ATTACHMENT A

PROPOSED CHANGES TO APPENDIX A,

TECHNICAL SPECIFICATIONS OF FACILITY

OPERATING LICENSES NPF-37, NPF-66, NPF-72 and NPF-75

FIGURE 3.4-4

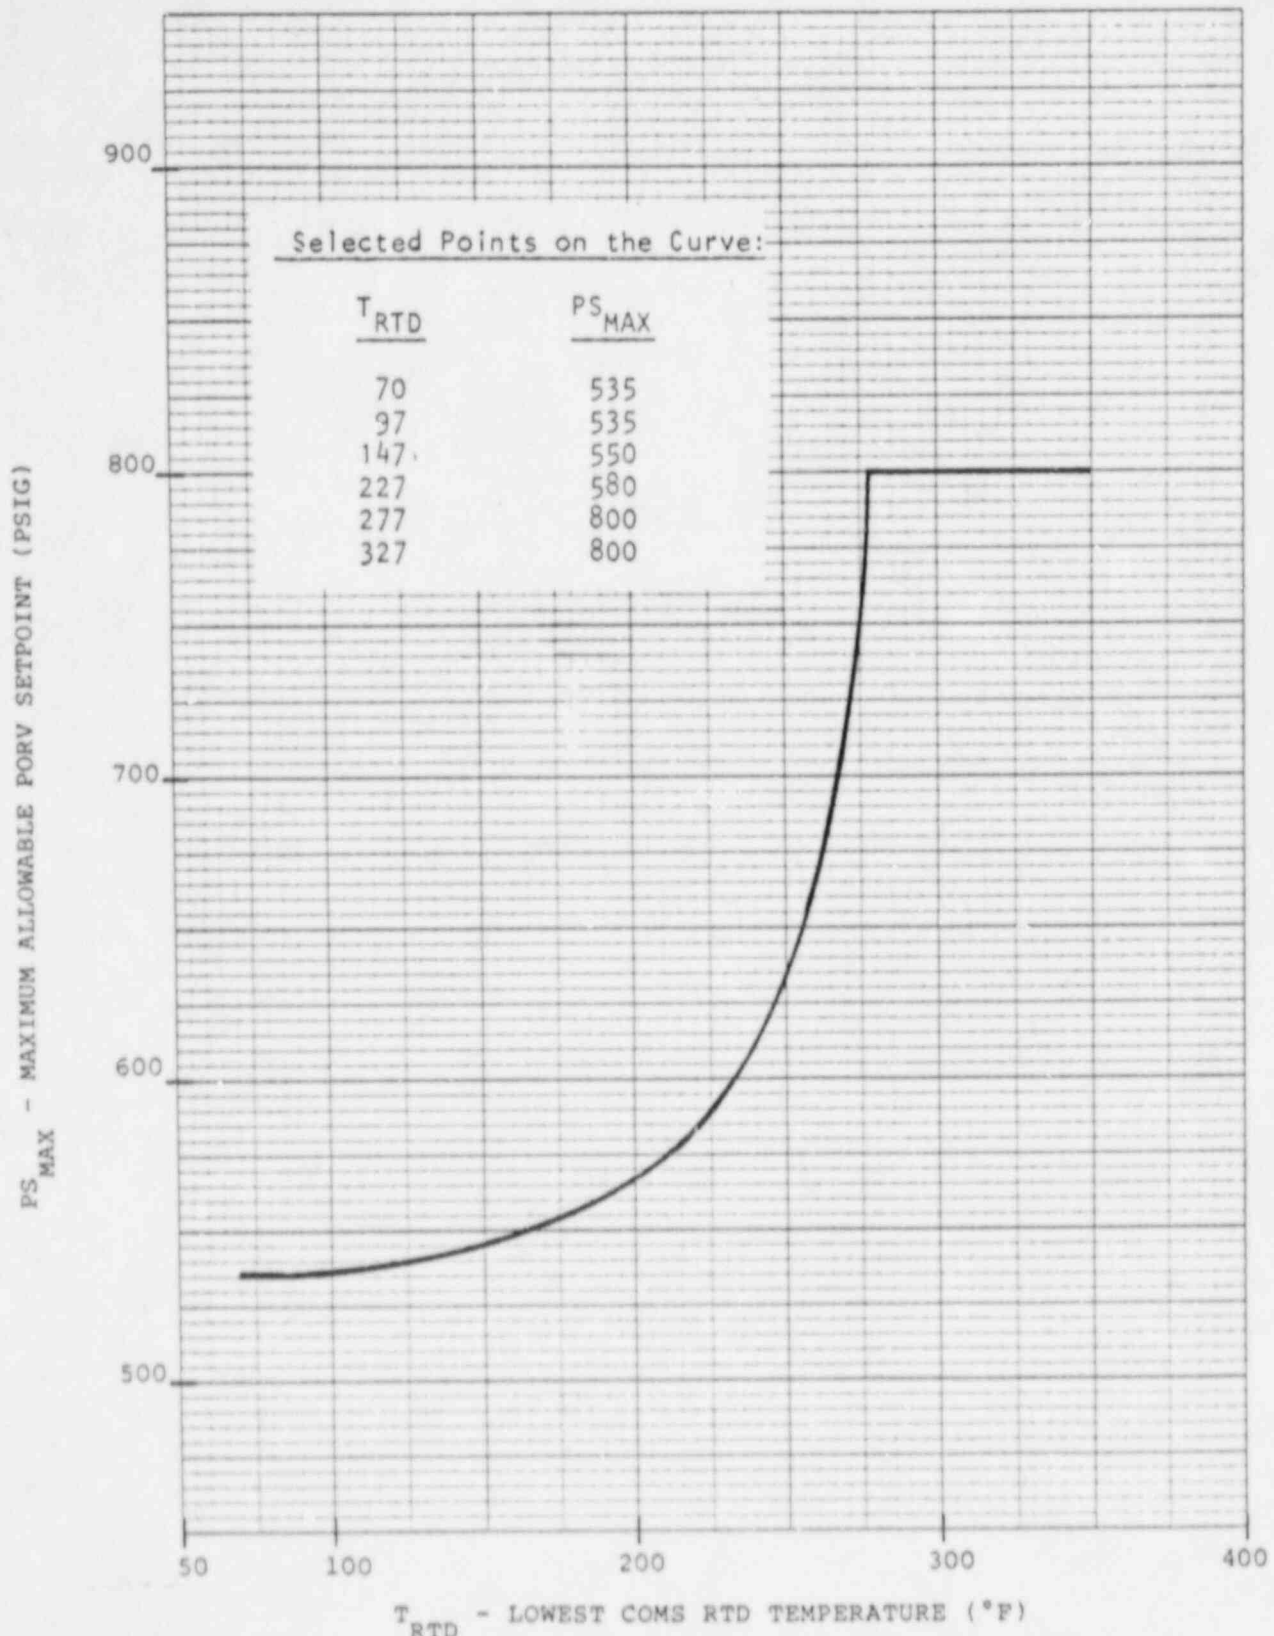
- 2) Cold Overpressure Protection System Setpoints, Figure 3.4-4, (page 3/4 4-40)

This change is requested based on a letter from Westinghouse indicating two changes should be made to the current Cold Overpressure Protection system curve in the Technical Specifications. The first change is to accommodate a larger wide range temperature uncertainty than had been previously utilized. Secondly, the revised Figure eliminates the need for a detailed evaluation of resultant stresses in the PORV inlet and discharge piping and steam generator tube sheet following a single overpressure event. The proposed change to Figure 3.4-4 reflects these revised setpoints.

Since the cold overpressure protection response setpoints are more conservative than the current Technical Specifications the margin of safety does not involve a significant reduction.
